Access Compliance Report

Public Rights-of-Way

Intersection ID: 19459	Main Street: ECHODALE_DR	Cross Street: NATIONS_FORD_RD	Location: SW
ADA ID: D7E4AC22677E	Ramp Type: PerpDiag	Initial Pass/Fail: Fail	Overall Compliance: No
		Severity Score: 12.5

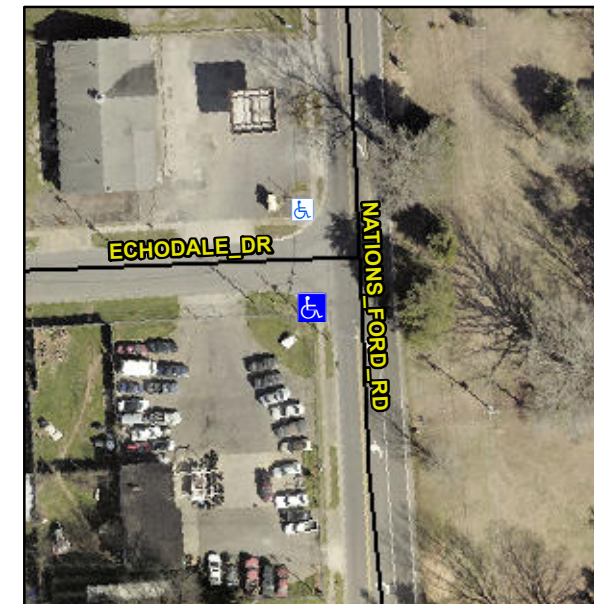
Compliance	Description	Data	Compliance	Description	Data
N/A	Ramp Length (in)	24.0	No	Ramp Slope (%)	8.8
Yes	Ramp Width (in)	48.0	Yes	Ramp XSlope (%)	0.2
N/A	Flare Type LT	N/A	N/A	Flare Type RT	N/A
N/A	Flare Slope LT (%)	N/A	N/A	Flare Slope RT (%)	N/A
N/A	Flare Traversable LT?	N/A	N/A	Flare Traversable RT?	N/A
N/A	Landing Length (in)	N/A	N/A	DWS Provided?	N/A
N/A	Landing Width (in)	N/A	N/A	DWS Contrast?	N/A
N/A	Landing Slope (%)	N/A	N/A	DWS Length (in)	N/A
N/A	Landing X Slope (%)	N/A	N/A	DWS Full Width?	N/A
N/A	Landing Curb? (Y/N)	N/A	N/A	DWS Offset (in)	N/A
N/A	Shared Landing?	N/A			
N/A	Gutter Ponding?	N/A	N/A	Gutter Slope (%)	N/A
N/A	Gutter Lip Ht (in)	N/A	N/A	Gutter X Slope (%)	N/A
N/A	Painted X Walk1?	No	N/A	Painted X Walk2?	No
	X Walk 1 Direction	To E		X Walk 2 Direction	To N
N/A	X Walk 1 Width (in)	N/A	N/A	X Walk 2 Width (in)	N/A
	X Walk 1 Slope (%)	7.3		X Walk 2 Slope (%)	1.2
	X Walk 1 X Slope (%)	3.6		X Walk 2 X Slope (%)	2.3

N/A	Ramp inside XWalk1?	N/A	N/A	Ramp inside XWalk2?	N/A
	Road Slope (%)	1.4	N/A	Clear Space?	N/A
	Road X Slope (%)	5.5	N/A	Clear Space to XWalk (in)	N/A
N/A	Any Obstructions?	N/A	N/A	Storm Grate/Utility Hazard?	N/A
	Obstruction Type			Storm Grate/Utility Type	
		N/A			N/A
			Yes	Surface Condition? (G/P)	Good

Remove & Replace Curb Ramp With Two New Directional Ramps or Equivalent.

R304.2.2
